Draft EIR for the Stagecoach Vineyard Expansion Erosion Control Plan Application # P06-0042-ECPA

Robert R. Curry
Registered Geologist and Hydrologist
December 30, 2007

This report addresses three fundamental questions about the Stagecoach Vineyards Erosion Control Plan Application (ECPA) #P06-0042-ECPA in the Atlas Peak area of the Rector Creek watershed in Napa County, California.

Effect of stone removal on soil loss

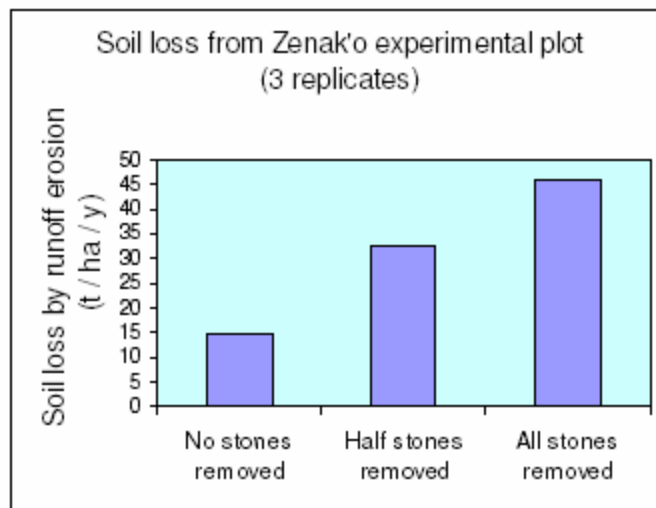
- 10) Site conversion with removal of stones from topsoil and shallow subsoil layers has been reviewed experimentally by Nyssen et al (2007) in volcanic, limestone and granitic bedrock terrains. This paper is particularly relevant because the stones are placed along the edges of the fields to capture sediment in sheetflow and rill runoff as is the proposed practice at Stagecoach vineyards. Nyssen compared three conditions: No stones removed, half the stones removed, and all stones removed. The following figure is from that paper:

Rainfall conditions at these experimental sites differ from those in Napa Valley but the overall strategies for erosion control are remarkably similar. Their data suggest a two to three times increase in soil erosion, even where cover crops exist seasonally, and further document that the stone berms or sediment retention rock walls and rock energy dissipators are only effective up to a limited capacity and storm intensity.
